# HISTORIC AND DESIGN REVIEW COMMISSION

March 17, 2021

**HDRC CASE NO:** 2021-100  
**ADDRESS:** 415 MISSION ST  
**LEGAL DESCRIPTION:** NCB 946 BLK 2 LOT 22  
**ZONING:** RM-4 H HS  
**CITY COUNCIL DIST.:** 1  
**DISTRICT:** King William Historic District  
**LANDMARK:** Individual Landmark  
**APPLICANT:** Fernando De Leon/One Stop Code Consulting  
**OWNER:** Jake Jazdzewski/JAZDZEWSKI JAKE & MONICA  
**TYPE OF WORK:** Relocation and exterior modifications to rear accessory structure  
**APPLICATION RECEIVED:** February 22, 2021  
**60-DAY REVIEW:** Not applicable due to City Council Emergency Orders  
**CASE MANAGER:** Stephanie Phillips  
**REQUEST:**

The applicant is requesting conceptual approval to:

drawing title: SITE PLAN

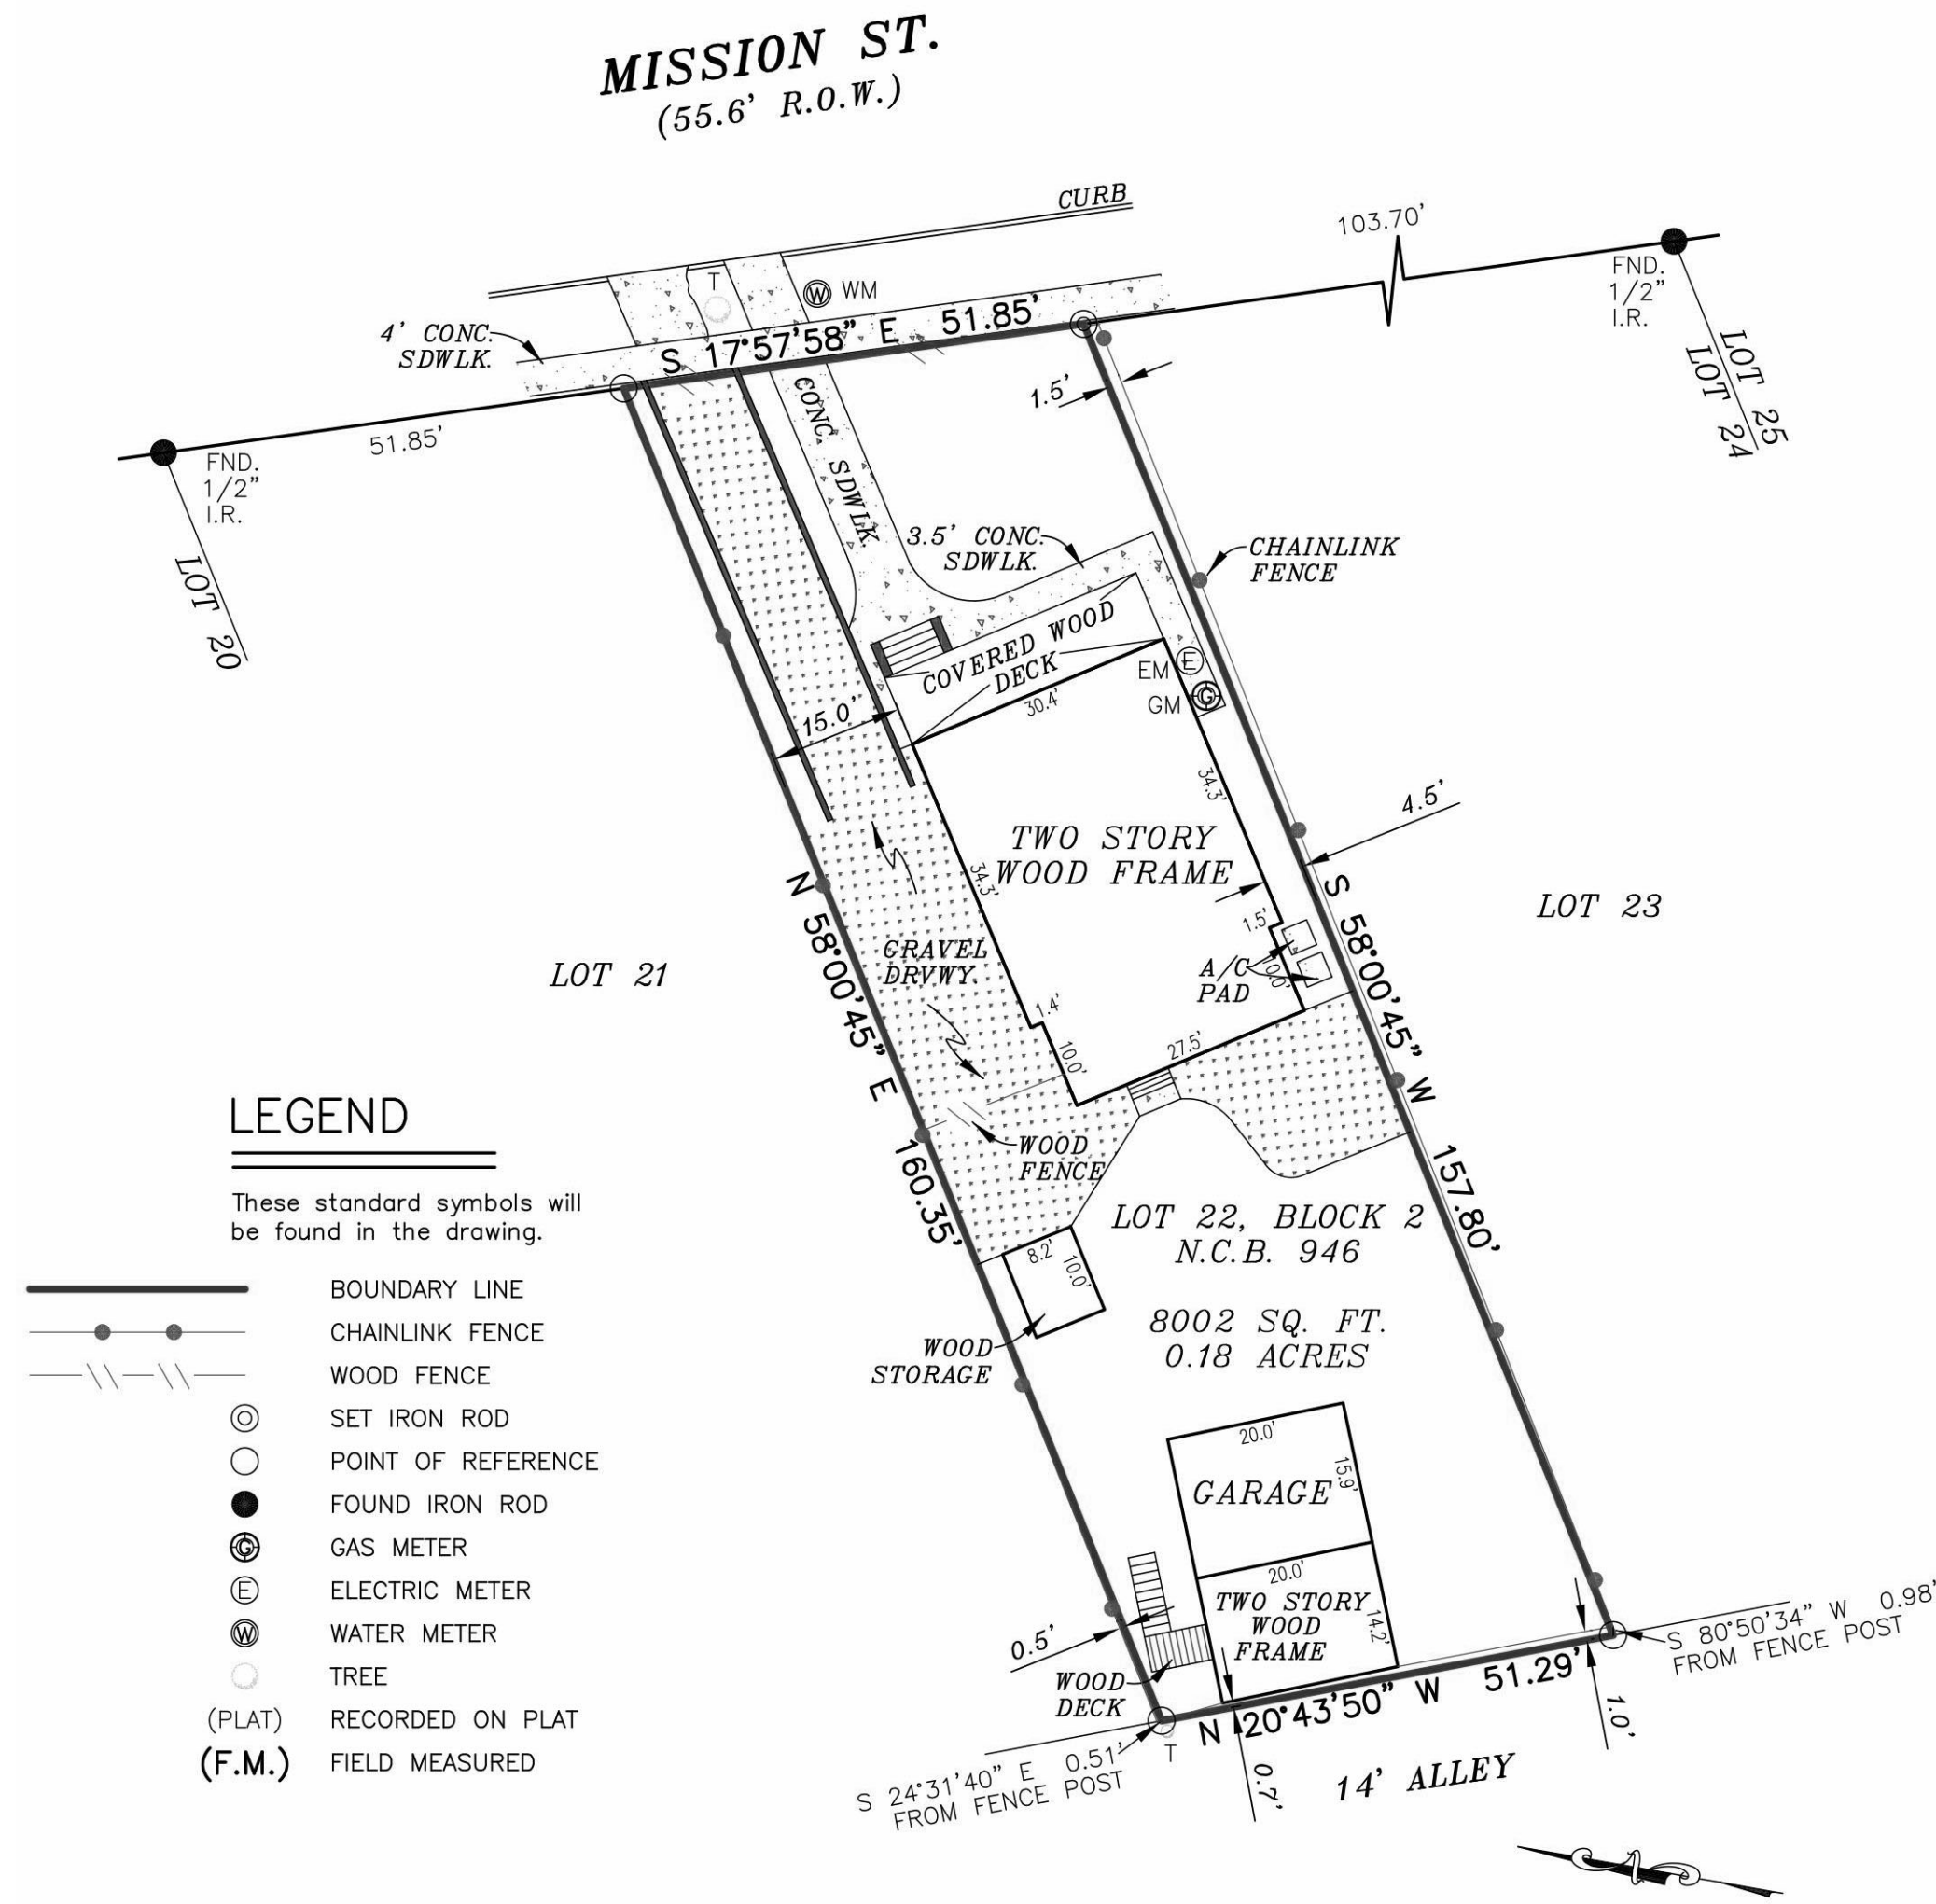
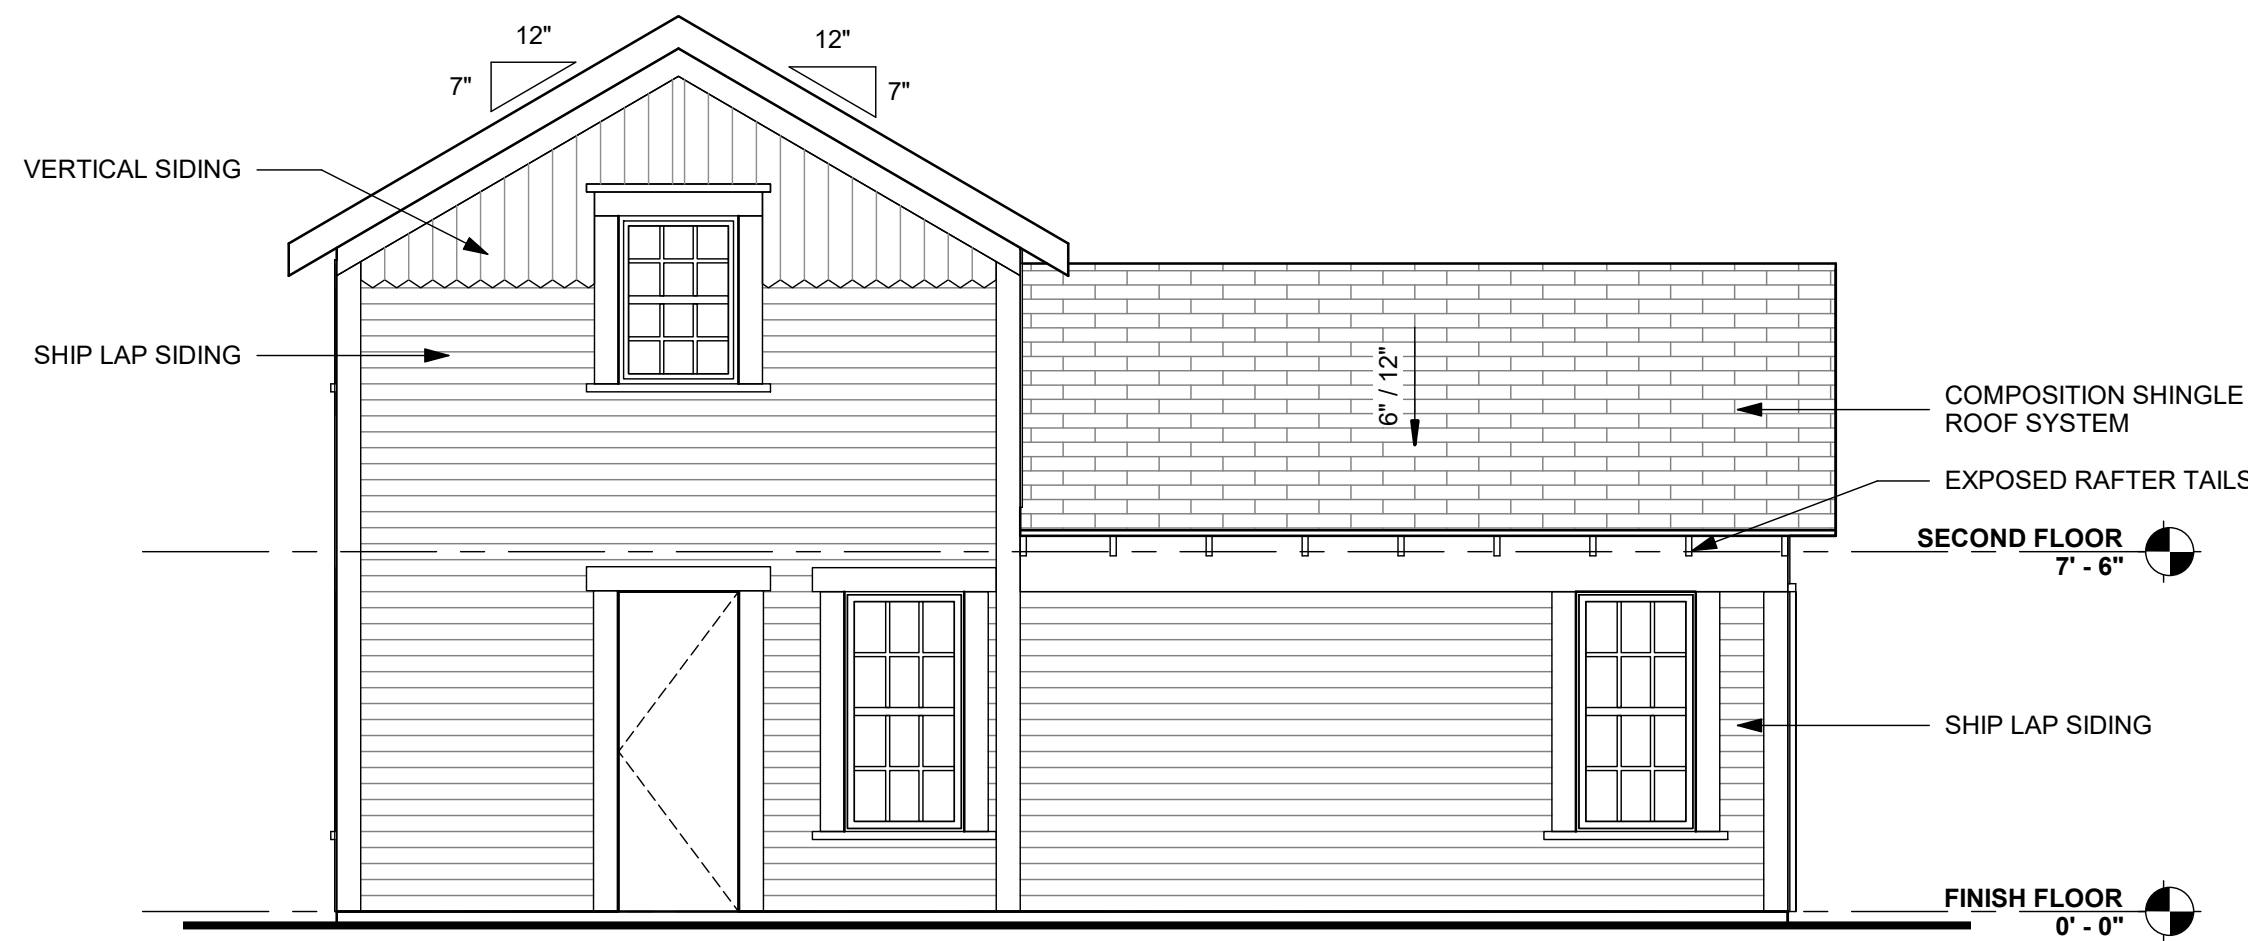
- c. **RELOCATION** – The applicant has proposed to relocate the existing rear accessory structure approximately 6 feet to the southeast to accommodate a new backyard configuration, to include an inground pool that is eligible for administrative approval. Staff generally finds the request to be appropriate due to its limited distance and retention of the historic development pattern of rear structures in the district. The new side setback is not indicated in the plans. The applicant may be required to obtain a setback variance from the Board of Adjustment.

- iii. That the applicant submits a detailed plan for structure relocation, to include stabilization measures and foundation details for the structure's new location, for final approval.
